Refactoring APSU FSMs to separate ILT and RTS functions (comments #132-137, 140)

Tom Huber, Nokia
Marco Mascitto, Nokia
Luz Osorio, Nokia

Figure 178B-10 “Training control state diagram” has three distinct purposes that should be separated

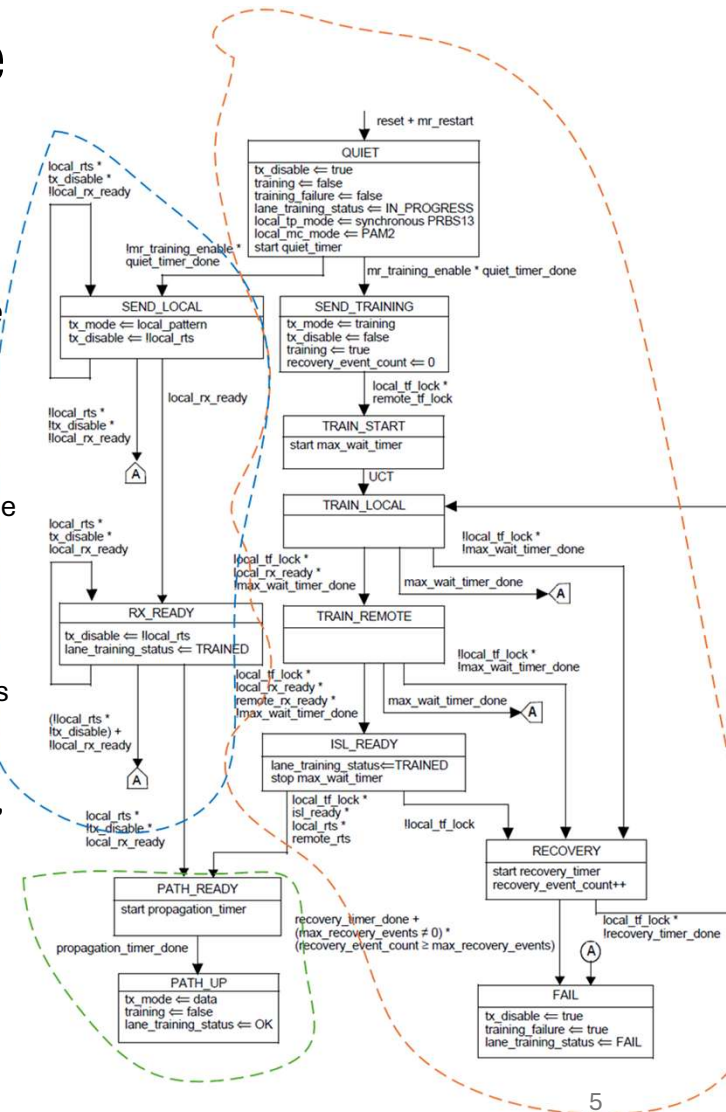
- The **orange** set of states (training mode) are related to ILT; these are *per-lane*
 - Two other FSMs (current figures 178B-11 and 178B-12) run when this FSM is in the TRAIN_START, TRAIN_LOCAL, and TRAIN_REMOTE states to control the details of lane training for 200G PAM4 ISLs via the local_tf_lock, remote_tf_lock, local_rx_ready, and remote_rx_ready variables

- These states should **not** control tx_mode for the interface; that needs to be controlled by the RTS function
- The **blue** set of states (local_pattern mode) are related to not-RTS or RTS signaling for an *interface* that does is not using ILT for training

- These states are showing transitions related to the RTS function (including control of what is transmitted)
 - If training is disabled (or maybe not supported at all) for an ISL, some other FSM or text should describe how isl_ready gets set to true, which is what the RTS function needs to see, and the RTS FSM should control the tx_mode transitions

- *Keeping the same interface into the RTS FSM for all ISLs makes RTS extensible*
- The **green** set of states are entered when both directions of all lanes for the interface are RTS; these are *per-interface*

- The RTS FSM is where tx_mode should be manipulated
 - *Using the training frame structure to signal RTS status does not make that signaling part of the ILT process*

Figure 178B-9 “RTS update state diagram” should manage the overall RTS process, not just the transition to mission clock and setting local_rts

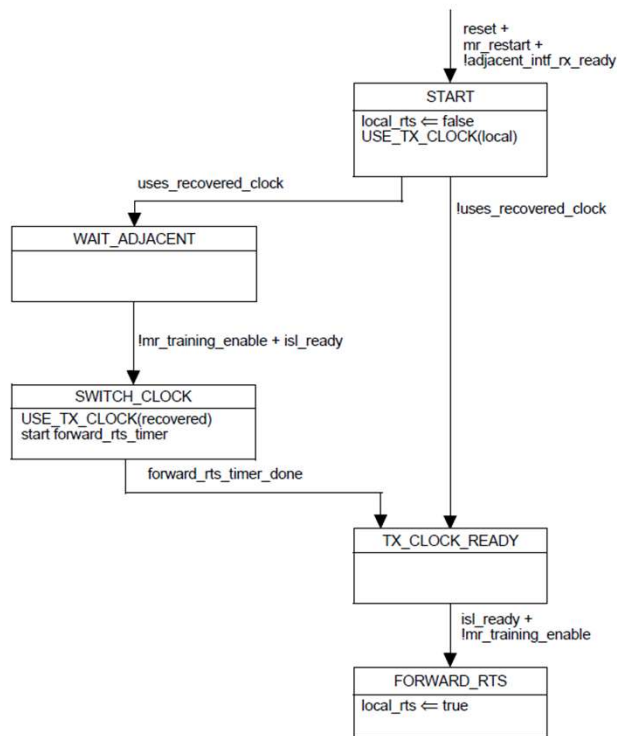
- There is nothing in this FSM related to the tx_mode for the interface
 - tx_mode manipulation needs to be here to enable RTS support on PMDs that don't use ILT
 - Relates to the green states in figure 178B-10
- mr_training_enable should not appear in this FSM
 - The RTS function should not depend on whether or how training is done; it just needs an indication that training is done
 - Relates to the blue states in figure 178B-10
- There is no provision for local_rts or remote_rts becoming false after it has been true, other than resetting the interface
 - This topic is addressed in osorio_3dj_01_2605
- As slavick_3dj_03_2603 showed, some states in this diagram can be compressed

ILT FSM

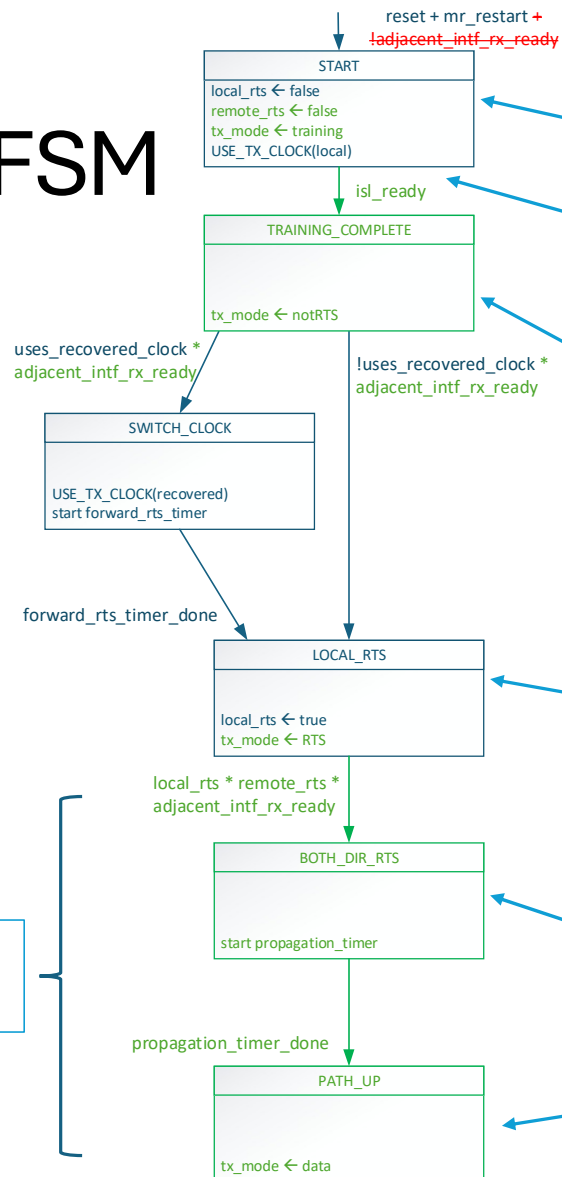
- Retains the orange states shown on slide 5, except for the minor changes shown in red
 - local_rx_ready set to false in the QUIET state for clarity (existing definition means it must be false at this point)
 - mr_training_enable doesn't need to be checked; this FSM only runs on interfaces with training enabled
 - tx_mode is an interface parameter, so it should not be set by a per-lane FSM; the RTS FSM handles this
 - Renamed "ISL_READY" to "TRAINING_COMPLETE" and made it a terminal state (removing transition to RECOVERY); this FSM is done once configuration of the EQs is done
 - Fault handling is addressed in osorio_3dj_01_2605

RTS FSM

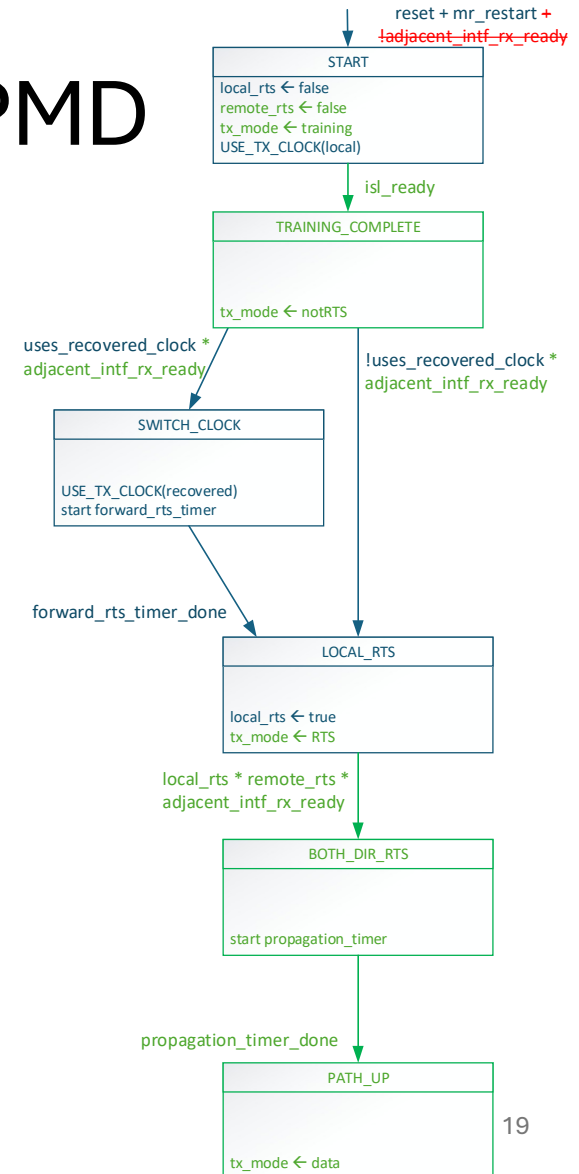
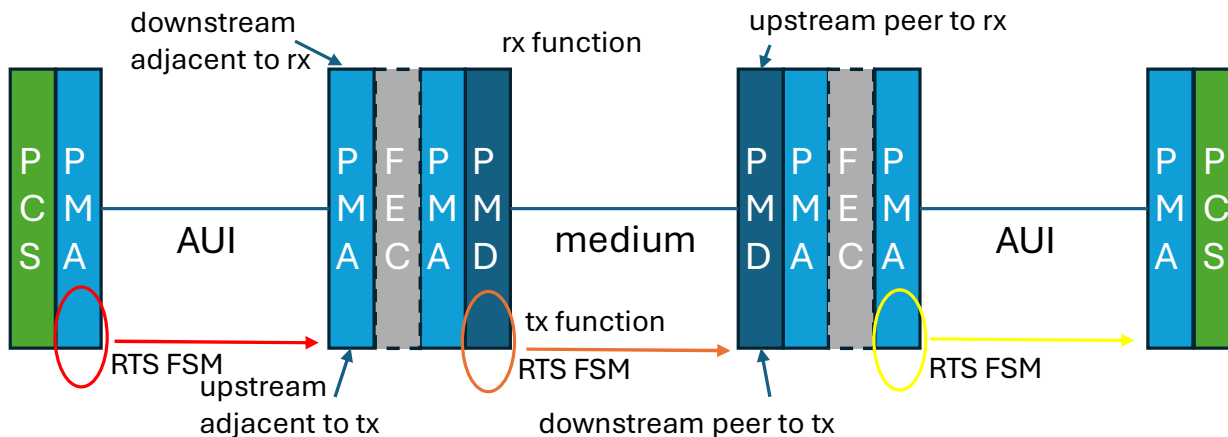
Removed !adjacent_intf_rx_ready, as that should not cause a restart of the entire RTS process. Fault handling in the context of this FSM is addressed in osorio_3dj_01_2605

Training (whatever that means for the ISL) happens in this state; when training is complete, isl_ready becomes true

isl_ready is set to true based on criteria that are specific to the PMD/AUI and what sort of training it does (this definition of isl_ready preserves the behavior of the blue states)

This new state means training is completed but the upstream adjacent interface is not yet RTS.

- new tx_mode = 'notRTS' means the interface sends whatever it sends when training is completed but it is not yet on mission clock or mission data. This can be specified in each PMD/AUI or in a table in Annex 178B. If the upstream adjacent interface is ready before training completes, one of the exit transitions is taken immediately after entering this state

This state means training is completed and the ISL has switched to mission clock

- new tx_mode = 'RTS' means the interface sends whatever it sends when training is completed and is on mission clock, but not mission data. This can be specified in each PMD/AUI or in a table in Annex 178B.
- If remote_rts becomes true before getting to this state, the exit transition will be taken immediately upon entering

Moved from figure 178B-10 because these states are about RTS

This is the "PATH_READY" state in current figure 178B-10

This is the "PATH_UP" state in current figure 178B-10

Figure 178B-3—RTS and ILT functions within interfaces

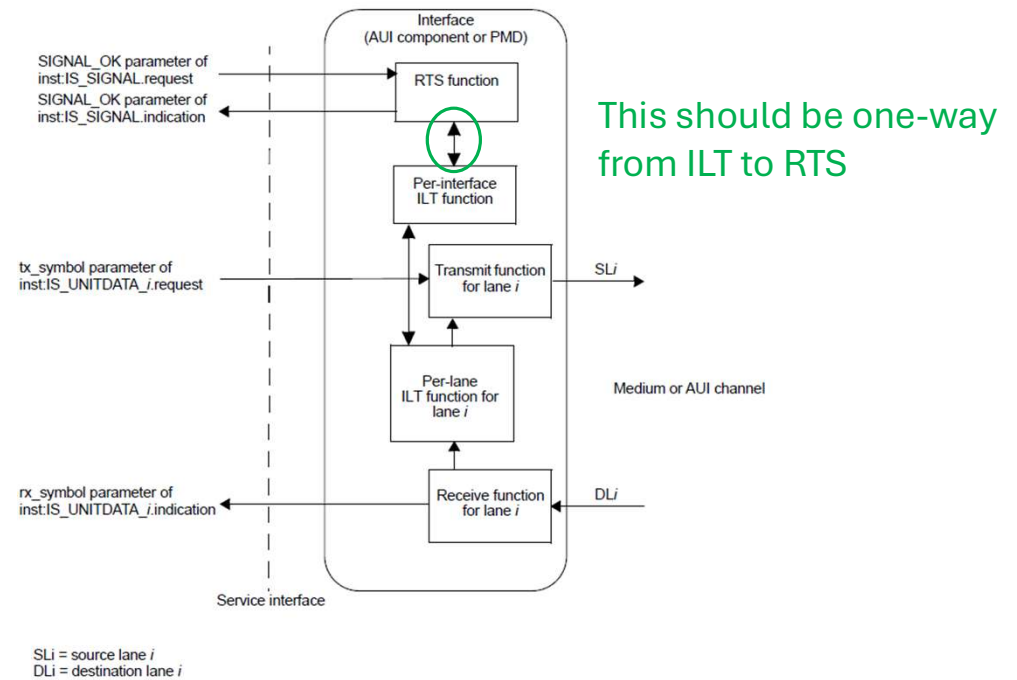
CI 178B	SC 178B.5	P 868	L 8	# I-132
Huber, Thomas		Nokia		
Comment Type	TR	Comment Status	X	
<p>Figure 178B-3 shows bidirectional communication between the RTS and ILT functions. This is presumably the result of the choice to use the ILT training frames to signal RTS information on 200G IMDD PHYs - but that choice doesn't make the RTS signaling part of the ILT function. There is no need for the RTS function to communicate to the ILT function.</p> <p><i>Suggested Remedy</i> Change the arrow between ILT and RTS to be one-way from ILT to RTS. Further detail will be provided in a presentation</p> <p>Proposed Response Response Status ○</p>

With the refactored functions/FSMs:

- Per-interface ILT function is simply the aggregation of local_rx_ready and remote_rx_ready for each lane into isl_ready
- All other existing per-interface behavior is part of RTS

Figure 178B-4—Signaling between RTS and ILT functions

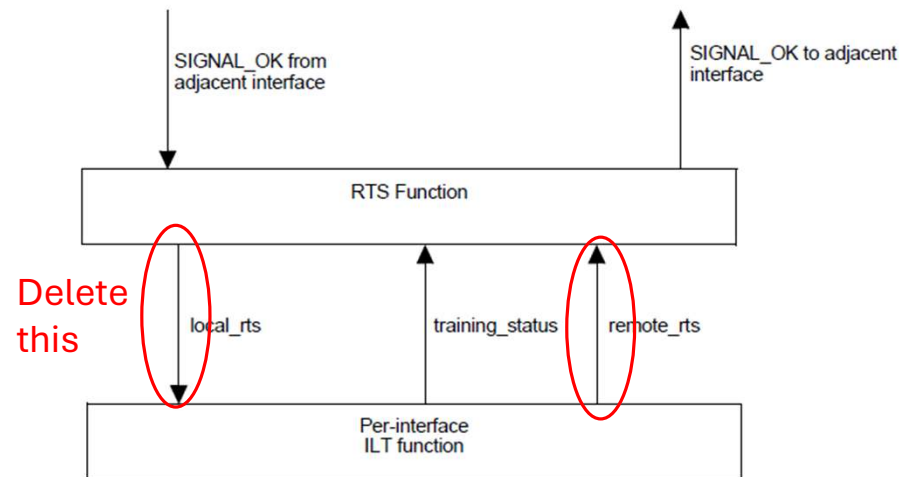
Figure 178B-4 shows local_rts as a signal communicated from the RTS function to the ILT function and remote_rts as a signal communicated from the ILT function to the RTS function. Since local_rts cannot be true unless the ILT function is complete on every lane, the ILT function cannot possibly depend on local_rts. Remote_rts is unrelated to training the link, so it should not be coming through the ILT function, it should be a direct input to the RTS function. The confusion seems to be that the same frame structure used for ILT is used to signal RTS for 200G IMDD AUIs/PMDs - but that doesn't make the RTS signaling part of the ILT function.

Revise figure 178B-4 to not show local_rts and remote_rts as signals between the two functions, but rather to show a 'training complete' signal from ILT to RTS. Further details will be provided in a presentation.

- The suggested 'training complete' is already shown as training_status; this could be changed to isl_ready
- Delete local_rts and remote_rts signals, as those are entirely contained in the RTS function
